FARRAGUT MUNICIPAL PLANNING COMMISSION

AGENDA

October 21, 2021

C1.2
SITE LAYOUT PLAN
DRAWING

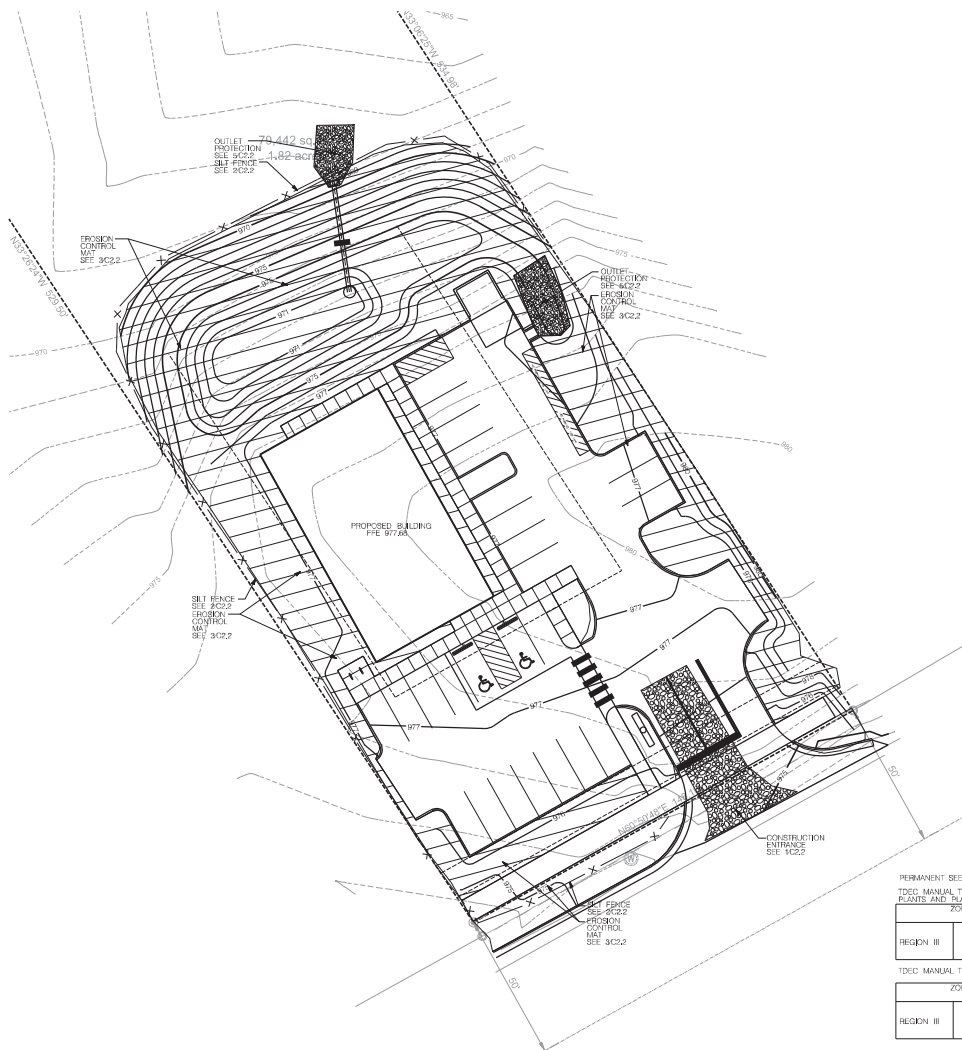
- 4 Provide building construction type. Provide height and area calculations. Provide building square footage.
[See architectural sheet](#)
- 5 Please ensure that the landscaped portion of the terminal island is at least 5 feet in width throughout its entire depth.
[Island modified to 5', see C1.2.](#)

- 6 This is mis-leading as the parcel is much larger than .85 acres.
[Note for acreage corrected on C1.2.](#)
- 7 Please provide a certified address for this project.
[Certified Address form is uploaded – see E911 Address Certificate.pdf](#)

- 13 Per the Parking and Loading section of the zoning ordinance, one additional interior island of at least 7 feet of width from inside of curb to inside of curb. Please add island to site plan.
[Island added to C1.2.](#)

- 17 This should be 6-30 curb & gutter along Kingston Pike (not just curb), most likely ending at edge of 8' walking trail.
[6-30 curb and gutter added to C1.2 and detailed on C2.3.](#)

DESIGNED BY	CHK'D	IN CHARGE	DATE
ISSUED BY	REVISED	DATE	DATE
PROJECT	250.009	SHEET	C2
DATE	08/20/21	SCALE	1"=50'

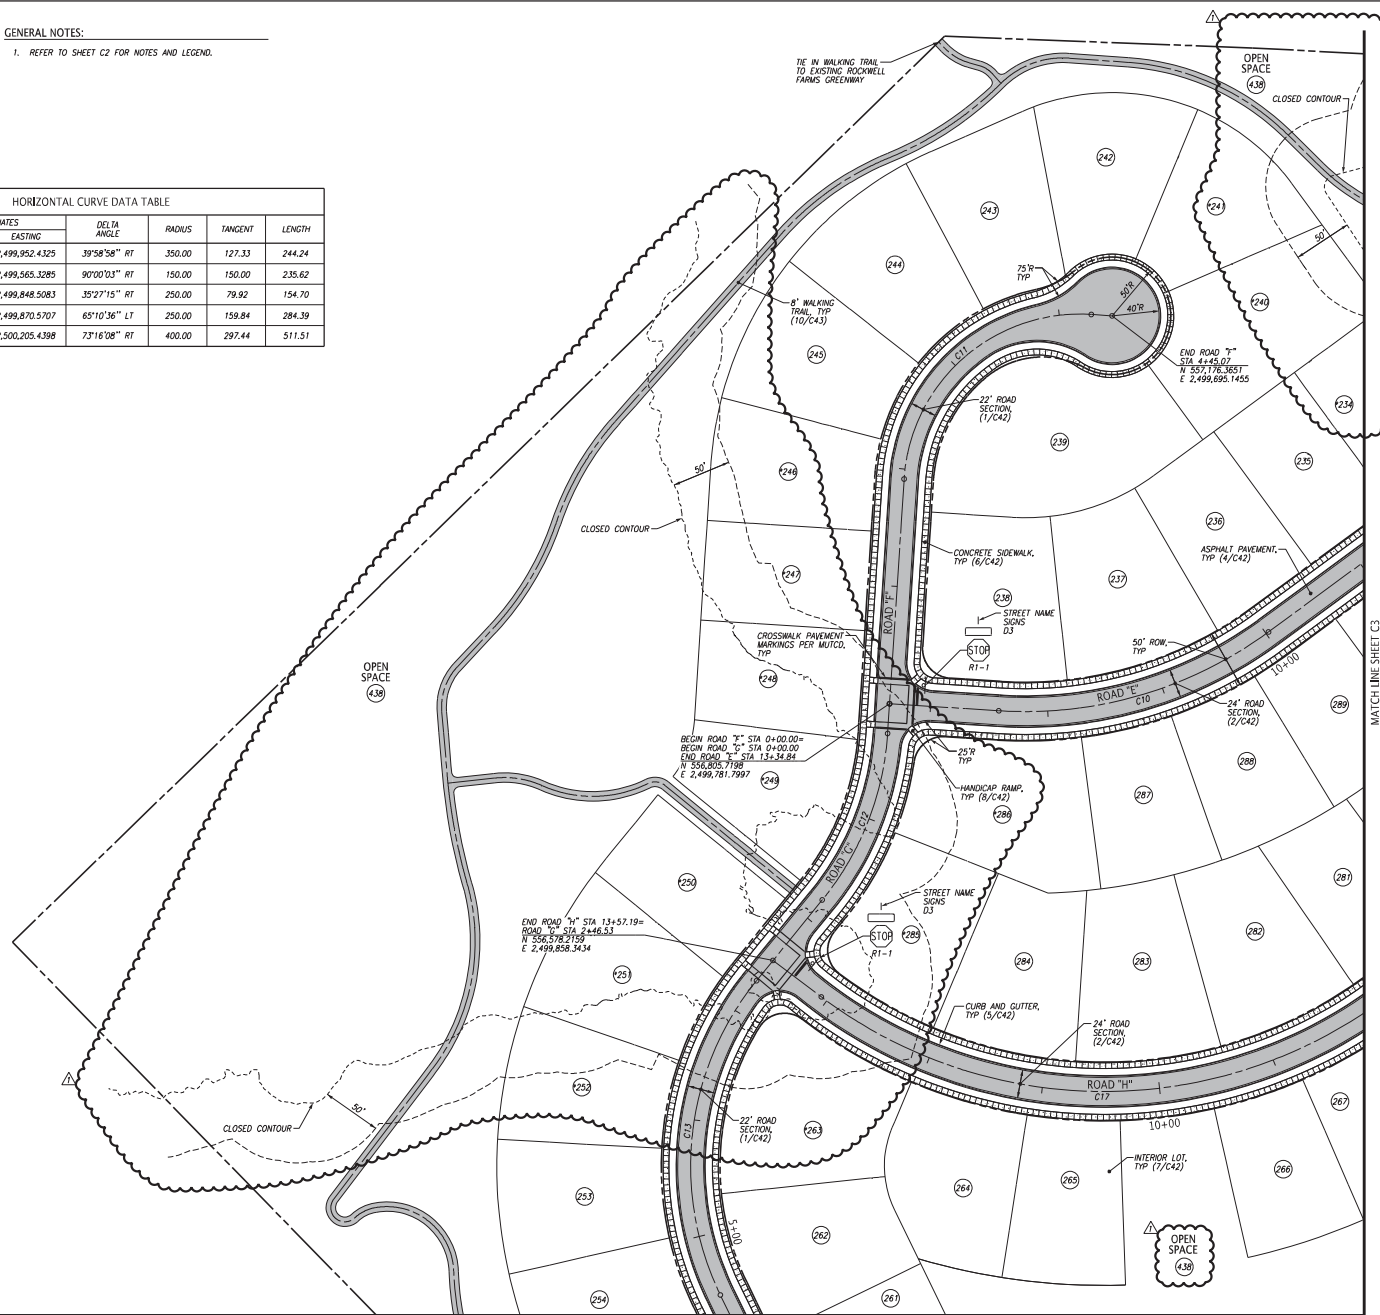
Comment 22: Please include a summary of the number of lots, open space, acreage involved, setbacks, building and lot coverage, etc., for these phases;

Comment 27: Please indicate which streets have been granted variance for reduced design speed;

Response 22: Please see notes 6 and 7 on sheet C2 for total number of lots, open space, acreage involved, and building setbacks. A table has been added to sheet C2 to show acreage and lot numbers associated with each phase. Is building and lot coverage a preliminary plat item or final plat item?

Response 27: Per phone conversation with Darryl Smith, design speed and edge of pavement to edge of pavement variances approved during master planning for Bridgemore Subdivision are shown on sheet C2.

Sheet
C5

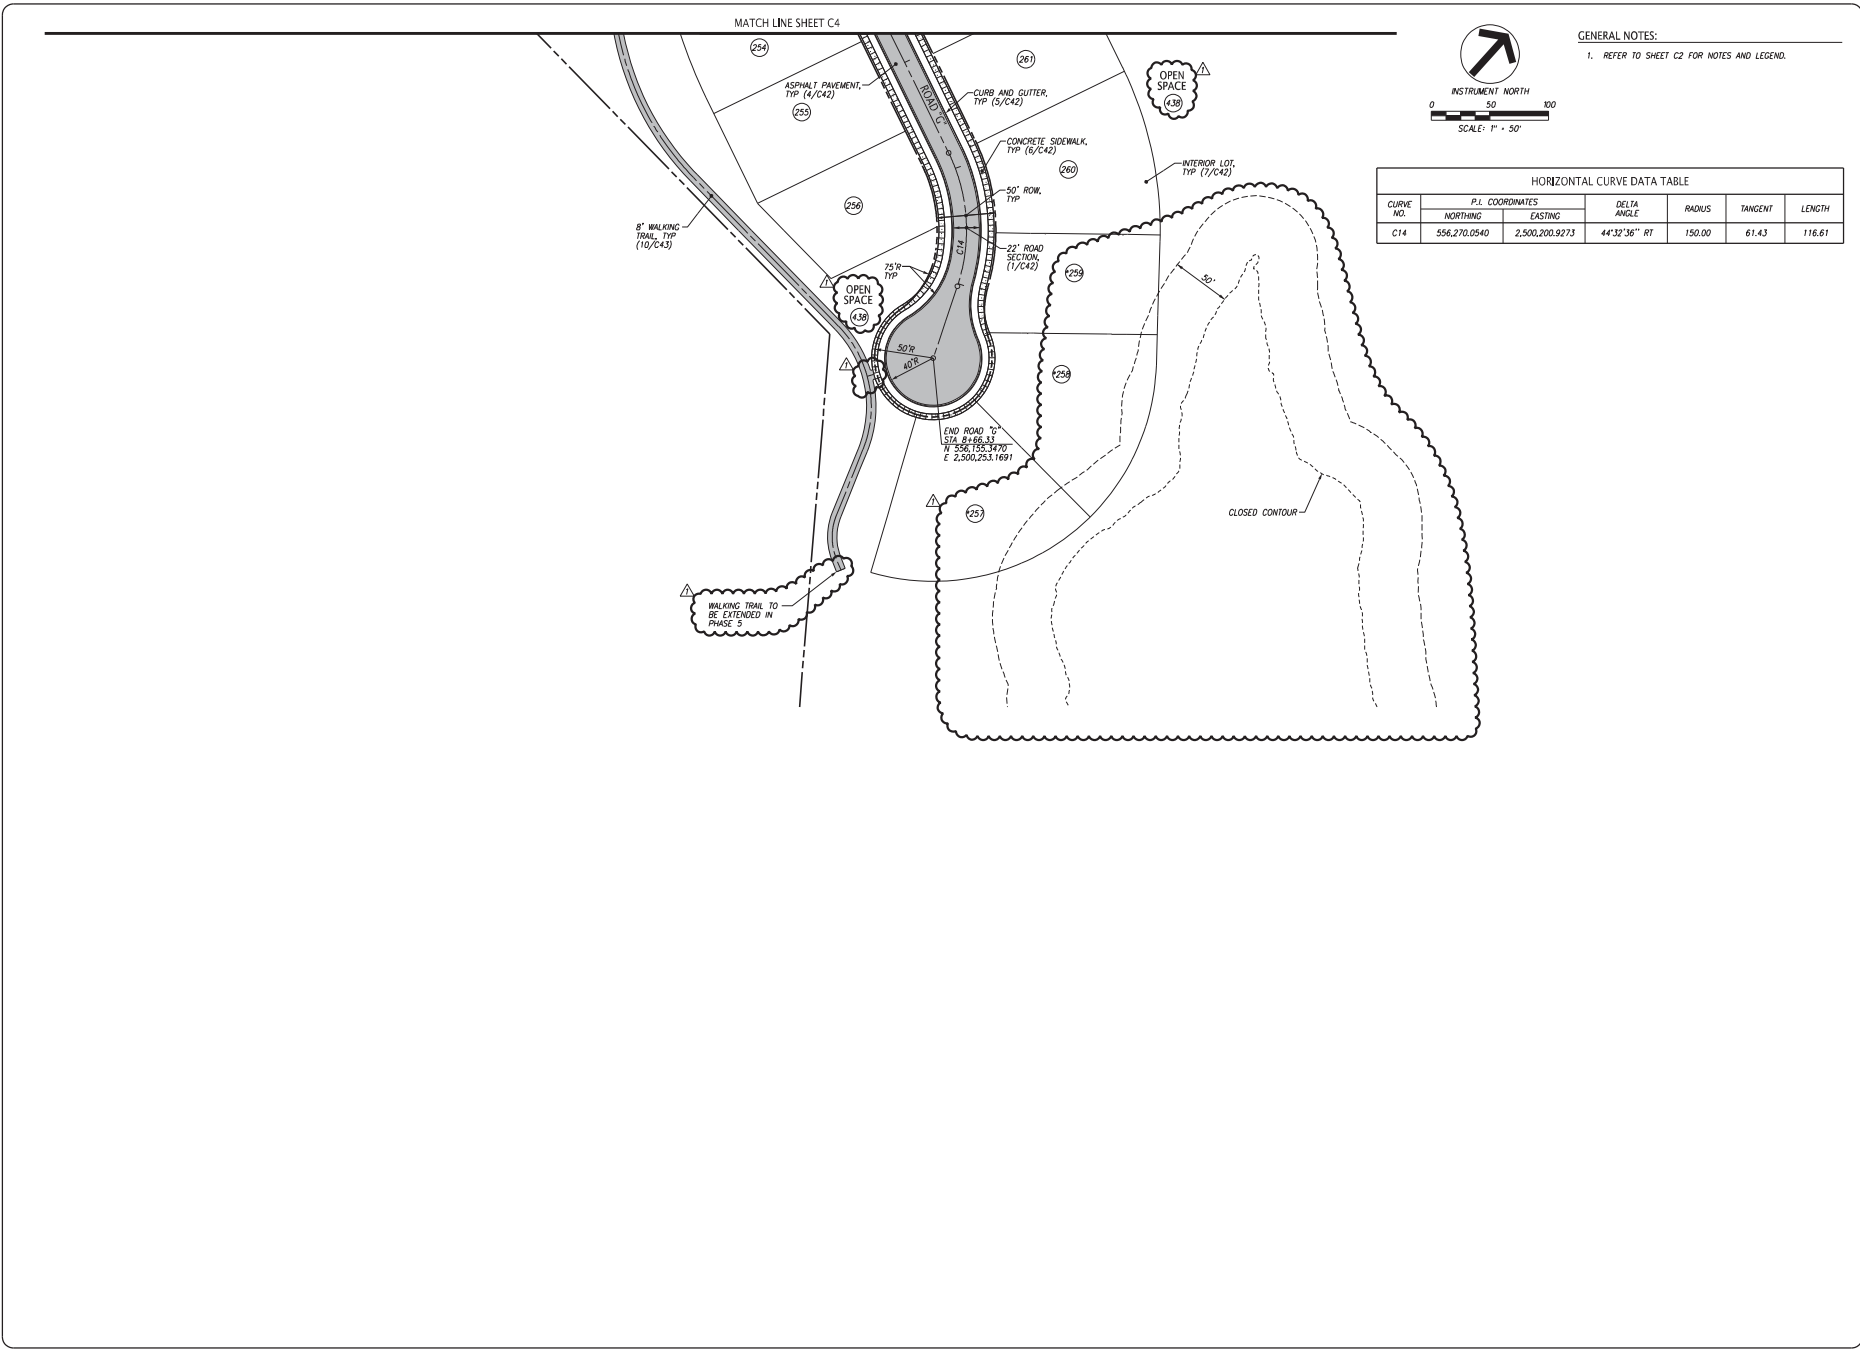
Comment 3: Please tie the sidewalk to the trail here;

Response 3: Complete. Please see revised sheet C5.
